**\*MANDATORY SERVICE BULLETIN\*****NUMBER:** SB-023**REVISION:** A**DATE:** 12/01/2009**SUBJECT:** ELECTRICAL SYSTEM; Main Power Feed Cable**EFFECTIVITY:**

MAIN POWER FEED CABLE INSPECTION: KODIAK 100 Series Aircraft Serial Numbers:

Quest Aircraft Company LLC. is mandating a one-time inspection to inspect the main power feed cable (main bus) on the electrical system for chafing which could occur if the main wire bundle was installed with excess slack. This Mandatory Service Bulletin provides directions for a one-time inspection and also provides parts to provide positive restraint if required.

**Figure 1-1:** Location of the Main Power Feed Cable

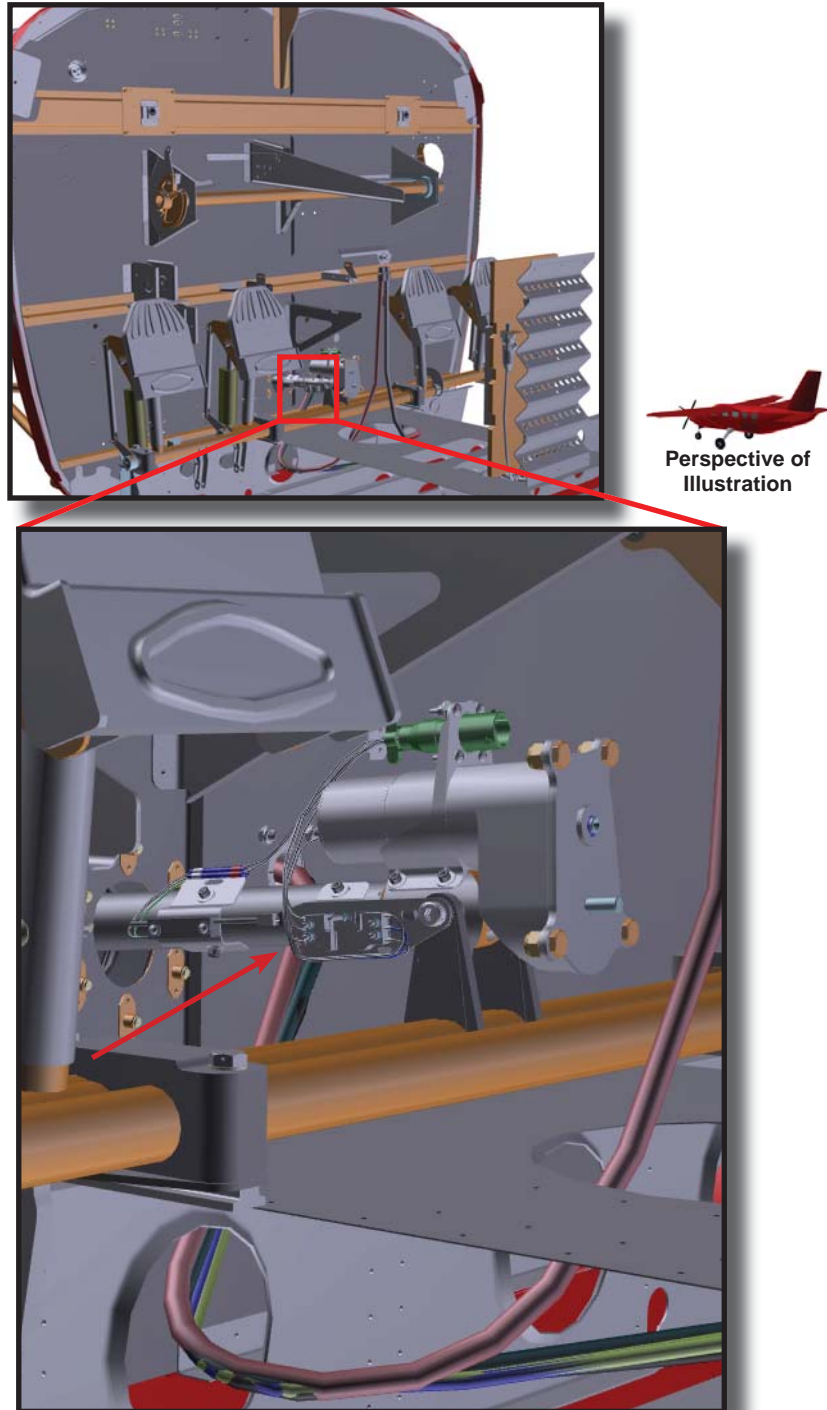
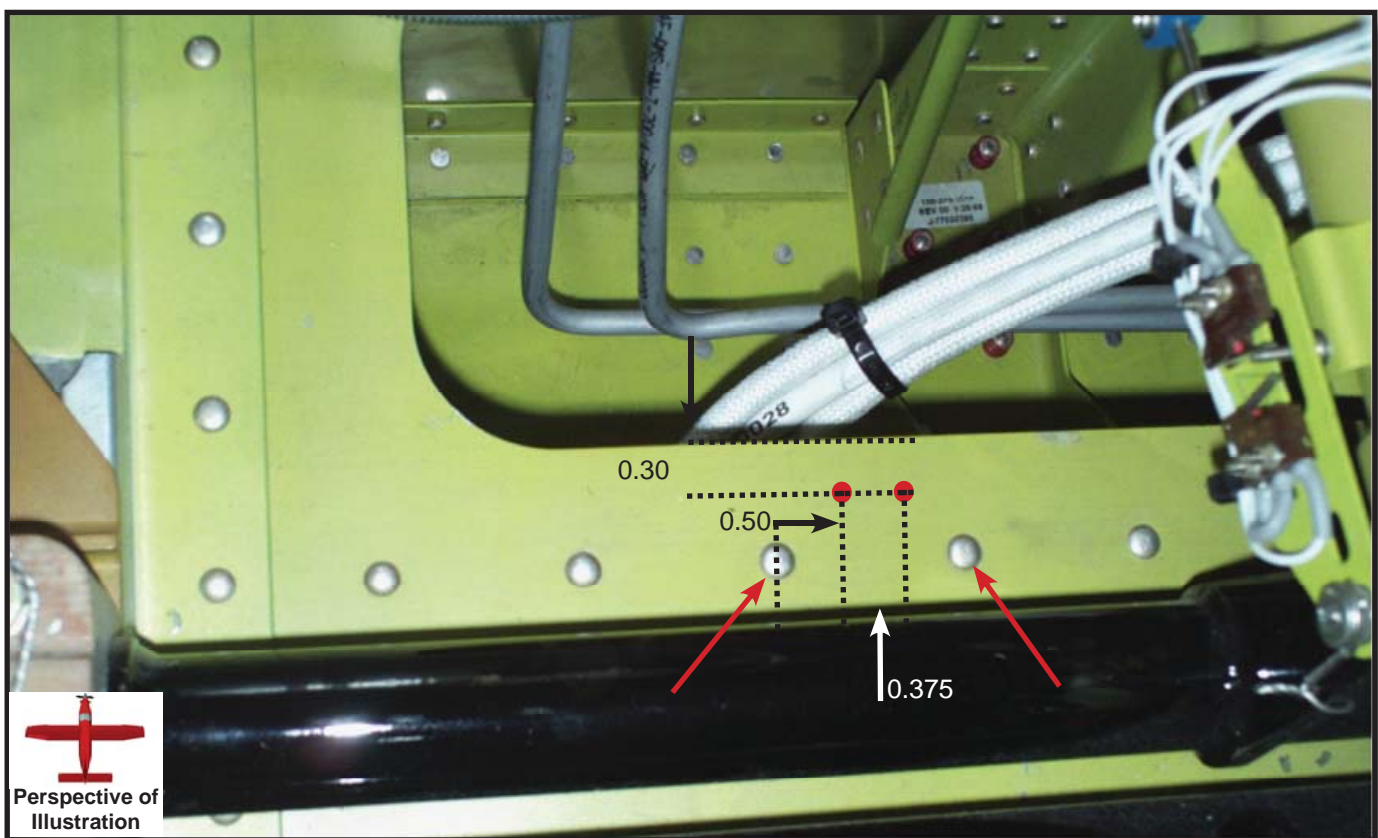
Locate the Main Power Feed Cable shown in Figure 1-1.

Turn the Nose Wheel fully to the left in order to position the Rudder Bungee at its lowest position. Placing two fingers under the Main Power Feed Cable and using light pressure, push upwards. If the Main Power Feed Cable comes in contact with the Rudder Bungee, proceed to **Step 1.3**. Also if the Main Power Feed Cable is able to come within 0.50 of the break lines below, proceed to **Step 1.3**. If the Main Power Feed Cable does not come in contact with the Rudder Bungee, proceed to **Step 1.6**.

**Figure 1-2:** Measurements for Rivet Hole Locations

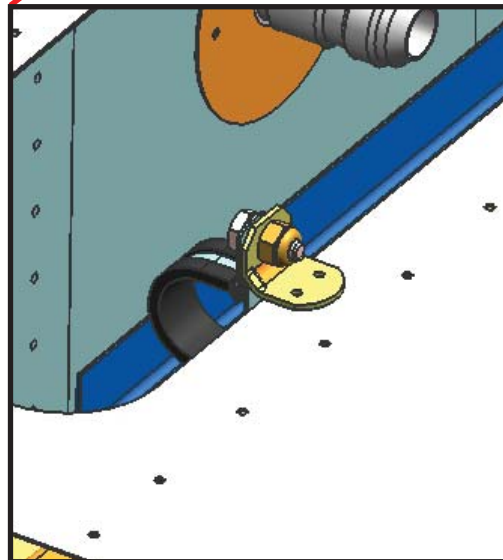
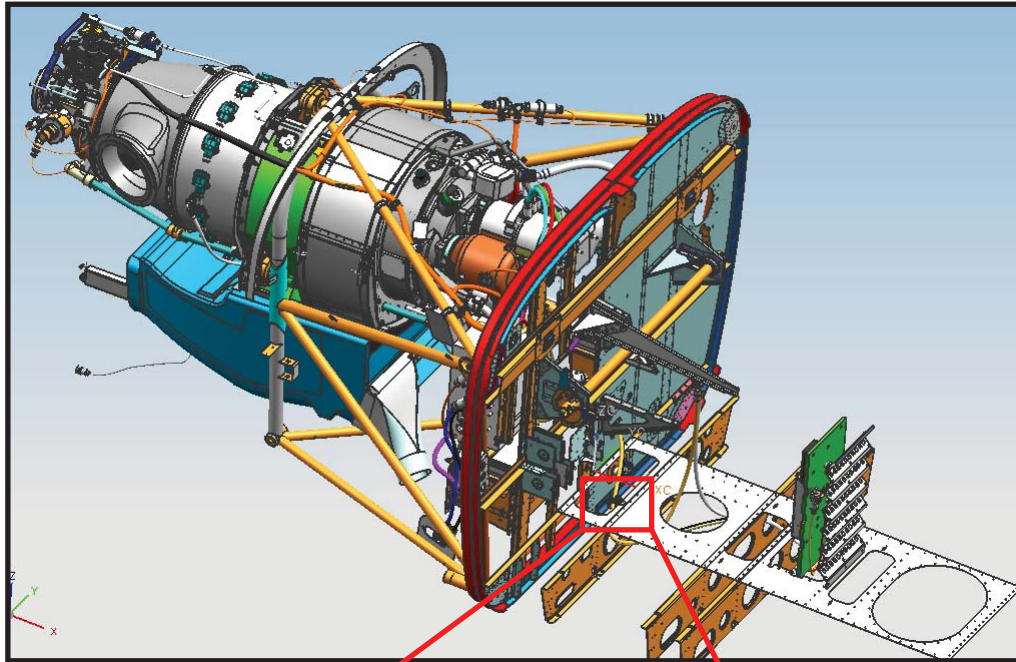
Locate the Rivets and mark the locations for drilling indicated in **Figure 1-2**. Using a #30 drill bit carefully drill out the holes for the **L Bracket (P/N 100-828-4051)**.

**NOTE:** The holes in the **L Bracket (P/N 100-828-4051)** may need to be widened with the #30 drill to match the diameter of the **ARN-4 (P/N CR3213-4)** rivets.
